### 23126 Frederick Road (Lovedale Montessori) CU-21-05: Day Care Center

Completed: March 26, 2021

Request for a Conditional Use to operate a Day Care Center (Over 30 Persons) for 42 children, on a 0.60-acre lot located at 23126 Frederick Road, Clarksburg, at the southeast corner of its intersection with Woodport Road, identified as Lot P5, Hammer Hill Subdivision, R-200 Zone, *1994 Clarksburg Area Master Plan*.

Figure 4: Proposed Site Plan

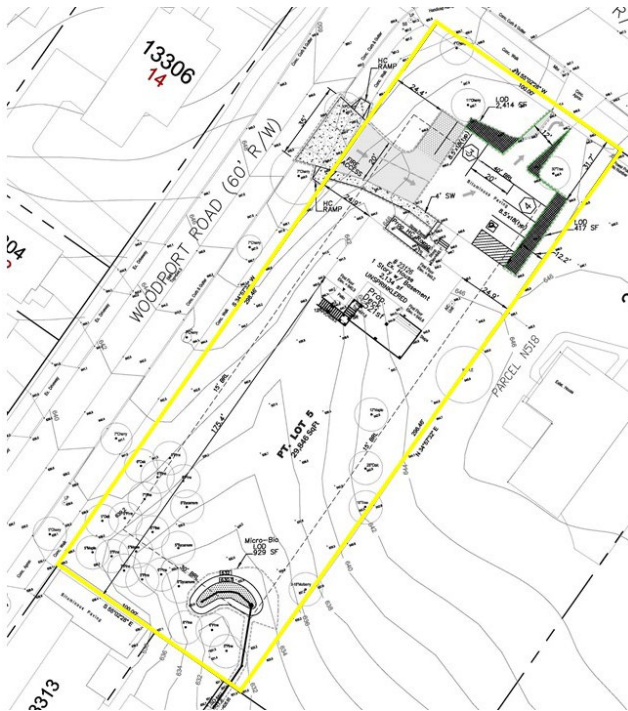
The Applicant is the owner of the Subject Property. The Applicant proposes to utilize the existing 2,134 square foot building with minimal alterations to the existing building or Site. The Site alterations would include a play area for the children in the rear of the Property, which is currently heavily screened by existing landscaping as well as established set back distance, a proposed deck to the rear of the structure and modifications to the existing parking area to accommodate access onto the property only from Woodport Road and right turn exit only onto Frederick Road.

Figure 5: Parking Lot Landscape Buffer

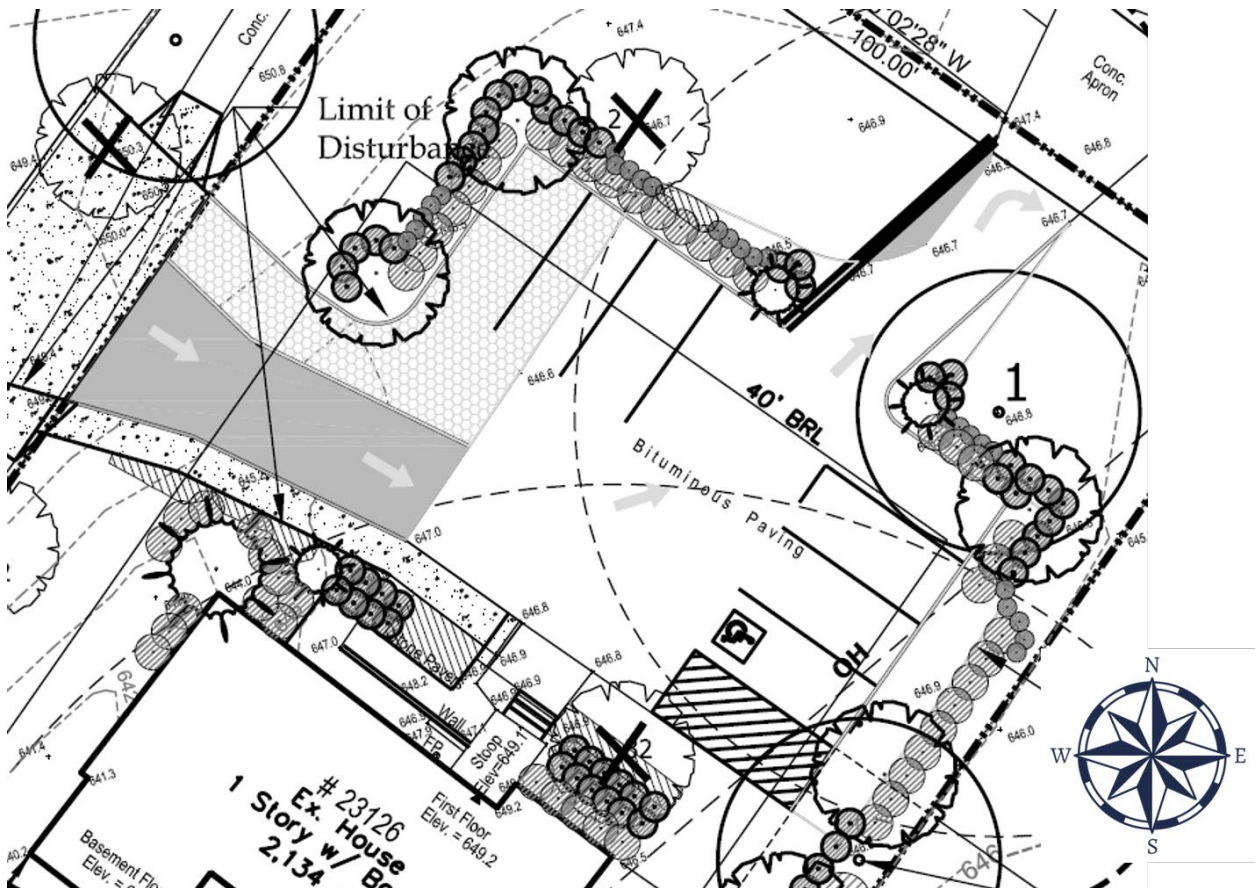
The revised Landscape Plan (revision date 02/11/21) satisfies the requirements of **Section 6.2.9.B.1 through 3: Parking Lot Requirements for Conditional Uses Requiring 5 to 9 Spaces**. The Applicant is showing a total of 7 surface parking spaces. The parking is located in front of the existing structure consisting of 6 standard parking stalls and 1 handicap parking stall. The parking area is set back approximately 25-feet from the western property line, approximately 30-feet from the northern property line and 12-feet from the eastern property line. There is a 5-foot wide landscape buffer between the parking stalls and western, northern and eastern property lines. The total length of this landscape buffer is approximately 118-feet. This buffer contains 2 overstory and 4 understory trees, and a hedge at least 4-feet in height satisfying Section 6.2.9.B. The parking is access via a driveway from Woodport Road with a right out exit onto Frederick Road (Figure 3).

Figure 6: Landscape Screening Eastern Property Line

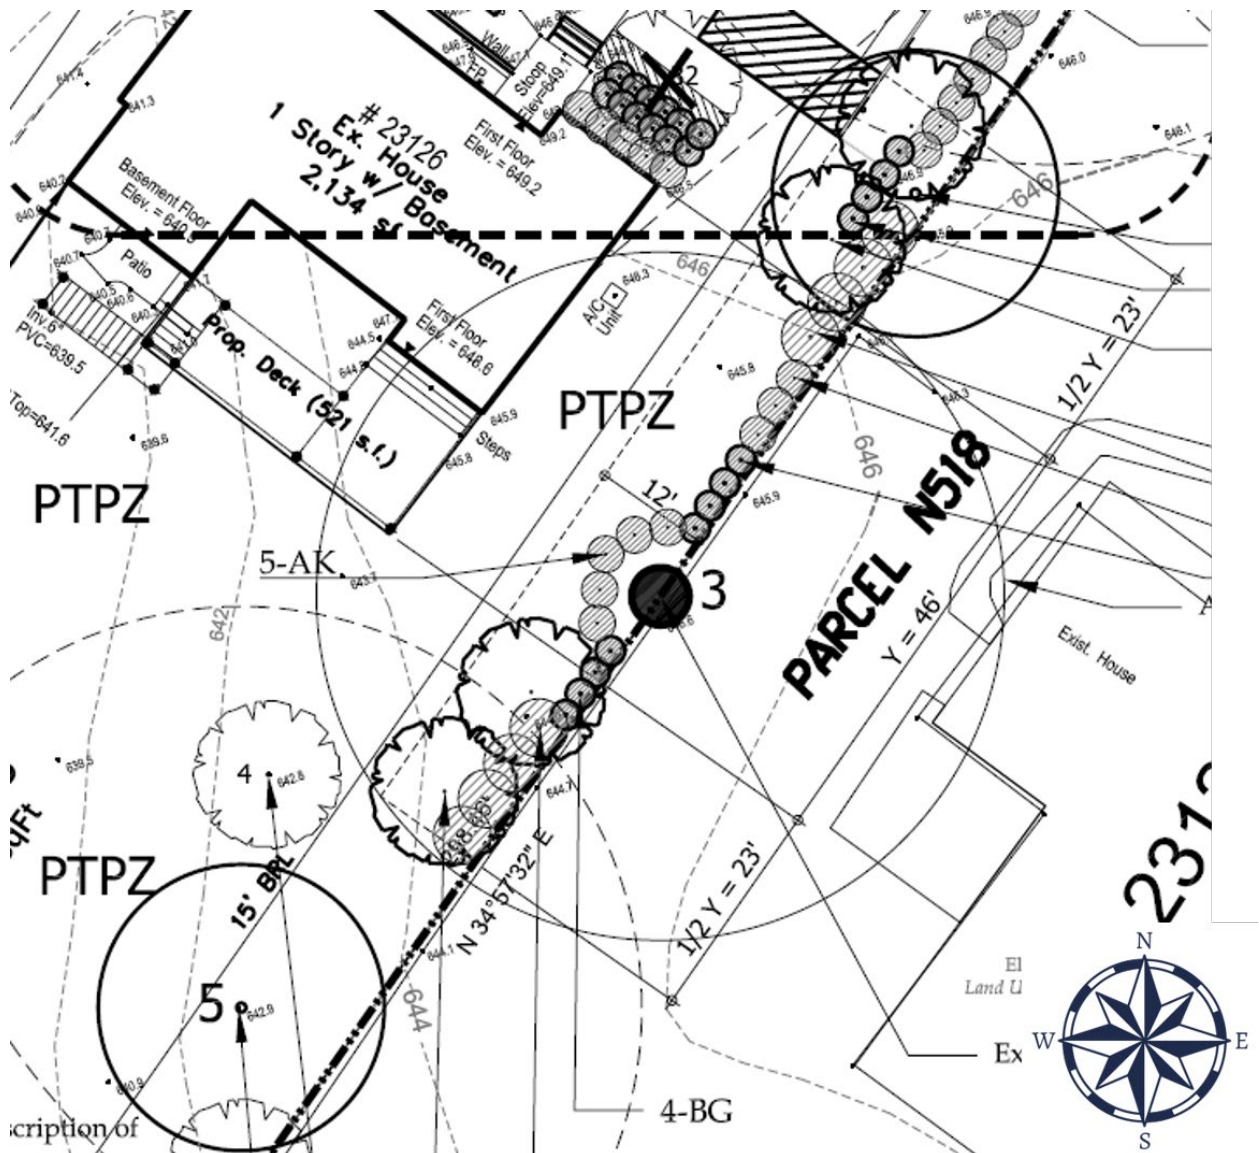
Along the eastern property line, the planting provided on the amended Landscape Plan meets or exceeds the minimum requirements of Section 6.5.3.C.7, Option B (**Figure 4**). The landscaping is placed between the lot line and the subject structure extending for the full length of the structure plus an additional 50% in length in each direction beyond the structure. The landscape planting area 92-feet long and 12-foot wide containing 2 canopy trees, 4 understory and evergreen trees, 8 large shrubs and 22 medium shrubs.

Figure 7: Landscape Screening Southern Property Line

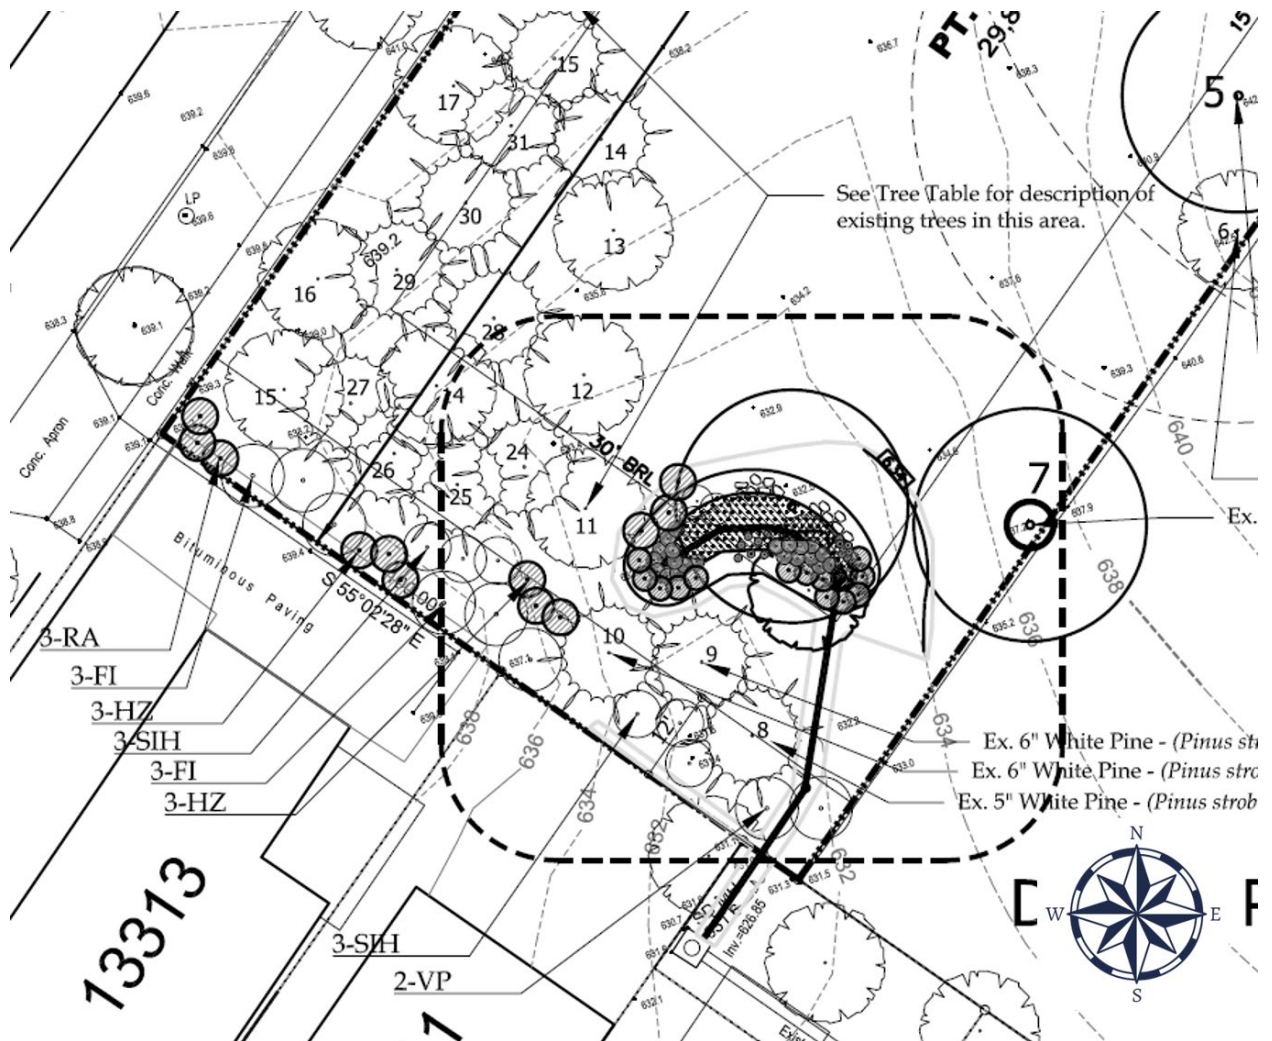
Along the southern property line the landscaping meets or exceeds the requirements under Section 6.5.3.C.7, Option B (**Figure 5**). There is a distance of 175-feet between the existing structure on the subject property and the residential structures to the south. There is existing screening along the southern property line along with an open grassed area. The existing screening along the south property line is comprised of 5 overstory canopy trees and 8 evergreen trees. The Applicant is also proposing to install 8 large shrubs and 15 medium shrubs along the property line. In addition to the existing and proposed vegetation, the Applicant will be installing one overstory tree, one understory tree, three large shrubs, thirteen medium shrubs, twenty-one small shrubs and groundcover grouped around a SWM micro bio-retention facility within this area adjacent to the southern property line.

Figure 8: Lighting Plan

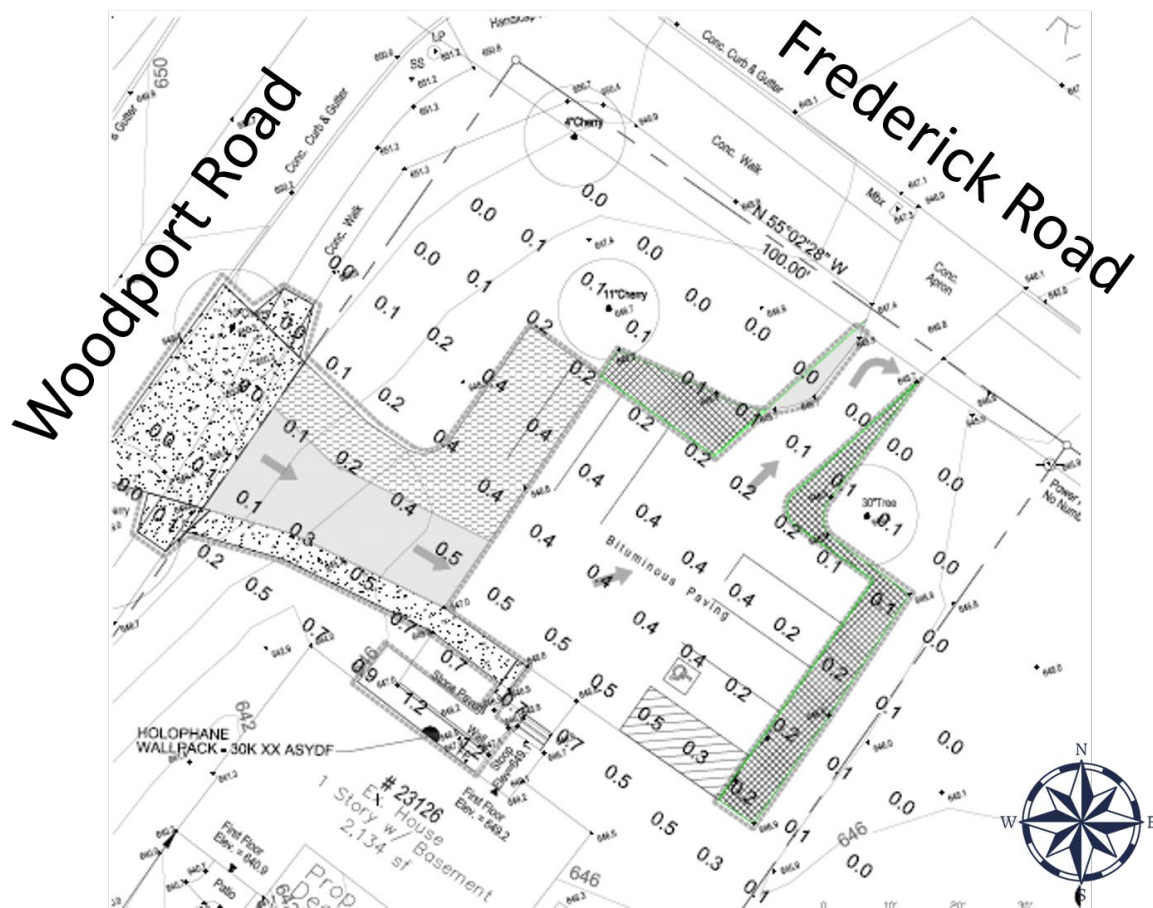
Pursuant to **Section 59 6.4.4.E**, outdoor lighting for Conditional Uses must be directed, shielded or screened to ensure that the illumination is 0.1 foot-candles or less at any lot line that abuts a lot with a detached house building type, not located in a Commercial/Residential or employment zone.

The Lighting Plan is adequate and safe for vehicular and pedestrian movement and does not unreasonably spill onto adjacent properties. The Applicant proposes to install one wallpack light fixture located at the front entry of the existing building (**Figure 6**). The proposed lighting provides illumination of the site entrance, visibility lighting in the employee parking areas and lighting near the front of the structure. A photometric study submitted with the Application shows measured lighting intensity across the area adjacent to the existing structure in foot-candles, the locations of lighting fixtures and the manufacturer's specifications on the proposed lighting fixtures. The Photometric Plan shows that the lighting will not cause glare on adjoining properties, nor will it exceed the 0.1 foot-candle standard at the side and rear property lines. The lighting, with no direct light or light glare, will not have a negative impact on neighboring properties.
